May 24, 2019

RE: Initiation of Section 106 Consultation for the Hirshhorn Sculpture Garden Revitalization and
Hirshhorn Museum Building Envelope Repair Projects

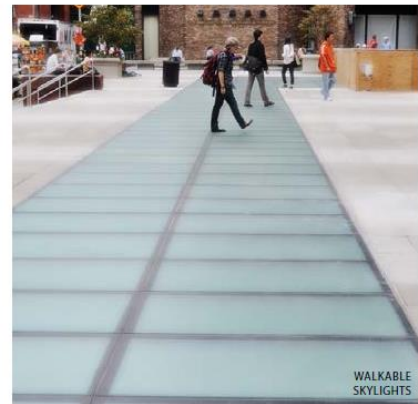
Bunshaft undoubtedly placed a great deal of importance on the museum's reflecting pool since he originally proposed that it span almost the entire width of the Mall's central greensward. Even when compelled to significantly reduce its size, he elected to design the pool using the same shape and proportions he selected for the one window that breaks the otherwise uninterrupted façade of the museum. This visual connection, which is illustrated in the image below, has remained intact since 1974. In our opinion, the pool must retain its original shape in order to avoid an adverse effect. Although we suspect it would be difficult to successfully achieve from a design standpoint, it may be possible to augment the pool with an additional feature or features.
